URGENT - FIELD SAFETY CORRECTIVE NOTICE**Getinge ED-FLOW**

Date:	26-JAN-2022
Product Issue:	ED-Flow Flooding, CAPA 424109
Affected Product:	Getinge ED-Flow AER and Getinge ED-Flow SD AER
UDI DI	No UDI – product not sold in USA and is not an MDR product.
SRN	N/A
Resolution:	<i>Getinge propose to repair the devices to make sure all devices present in the market are working effectively and safely.</i>
Affected Serial Nos.:	All ED-Flows manufactured since start 2010 until 2021-10-20.
Field Correction Notice:	N/A
Pages:	5

Ref.no: GD11046 Rev A

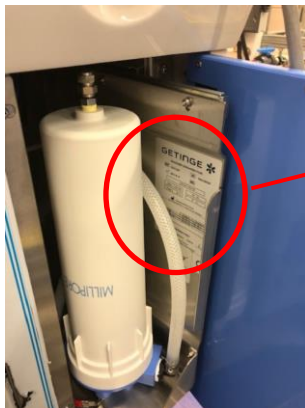
1. Check the serial number of the ED-Flow. The serial number shall correspond with the serial number on the customer response form (Appendix 1).
The serial number can be found on the marking label, located on the inside of the right Panel door, see below.
